# Value Engineering

FINAL REPORT

Chicago Ditch Dam Rehabilitation

DATE: December 23, 1996

Figure 12. Notched Trapezoidal Dam with Radial Gate on West Edge

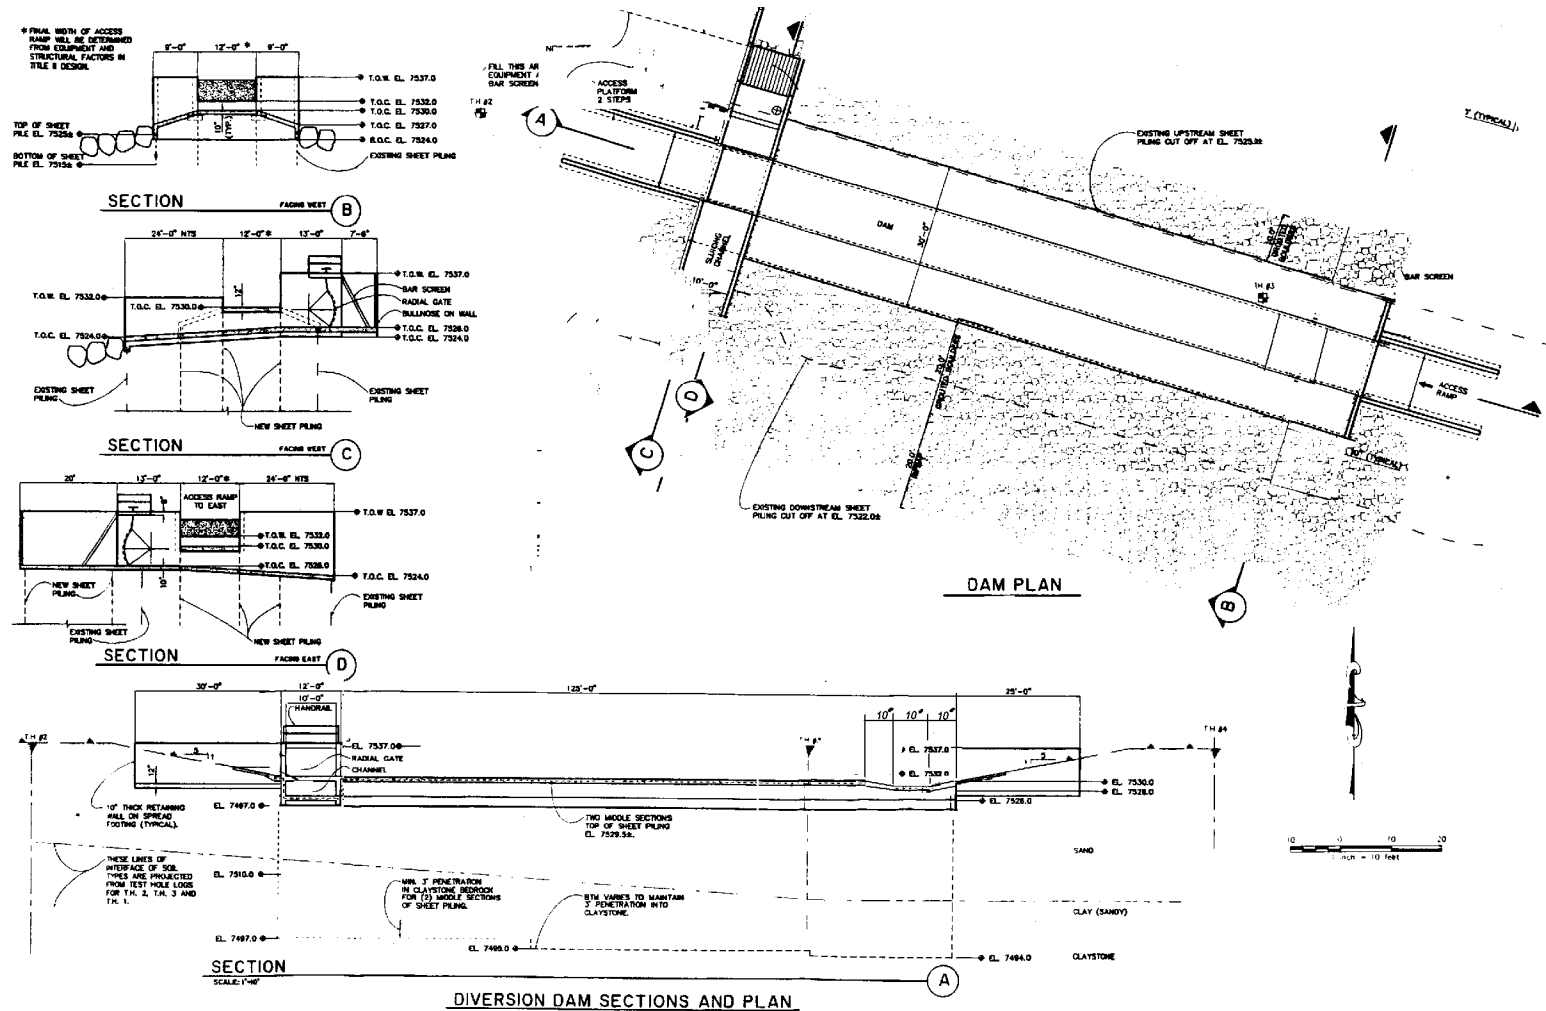
Allow more of the floating debris to pass over the diversion structure during periods of high flow. This would be accomplished by allowing it to pass over the structure at the location where it now accumulates on the east side of the diversion dam (on the outside of the river bend). By installing a notch or lowering a part of the crest on the east side of the structure, the flow velocity and depth for the river flows would increase. This would encourage the floating debris to go over the structure rather than accumulate near it.

Allow and encourage sediment debris to pass through a radial gate on the west side of the dam structure. (The Title I design locates the gate on the east side of the diversion dam.) The west (inside river bend) is the location where the sediment is now accumulating. The existing large diameter CMP would be completely removed during dam construction. The other smaller diameter CMP's would not be addressed at this time. However, they could be removed or replace upon their failure as required by maintenance personnel.

<b>PROJECT:</b> Chicago Ditch Dam Rehabilitation	
<b>COMPONENT:</b> Diversion Structure	<b>FUNCTION:</b> Raise surface (water)
<b>ALTERNATIVE DESCRIPTION</b>	
<p>Allow floating debris to flow out of the intake area and sediment debris to be passed through the diversion dam. Modify the design of the diversion structure by:</p> <ol style="list-style-type: none"> <li>1) Move the radial gate on the diversion structure from the east side (left side looking downstream) of the structure to the west side (right side looking downstream) of the structure.</li> <li>2) Install a low flow notch in the east side of the structure to ensure that floating debris will pass over the structure.</li> </ol>	
<b>BENEFITS</b>	<b>DISADVANTAGES</b>
<p>Easily eliminates much of the sediment debris from accumulating behind the diversion structure.</p> <p>Greatly increases the tendency to pass floating debris over the crest.</p> <p>Notch can be incorporated into any form of diversion structure discussed in this value study.</p> <p>Can be incorporated into future modifications of the crest if determined to be needed as river changes its flow versus stage relationship.</p> <p>The potential affect of winter ice buildup should be reduced.</p>	<p>Moving the gate to the east side would make the gate less effective for removing floating debris.</p> <p>Using a low flow notch would increase the depth of water in the notch compared to the remaining length of structure. This would require the operator to navigate deeper depths in the event they had to remove debris on the west side of the structure.</p>

<b>IDENTIFIED RISKS:</b>	
<p>Using a low flow notch may create high flood stages upstream. This should not be a problem if designed properly.</p> <p>There is a concern of the impact of beaver dams built or broken dam debris washed around the bottom of the radial gates. Since the gate would operate less frequently, the potential that the remains of a beaver dam would clog the gate region may be increased.</p>
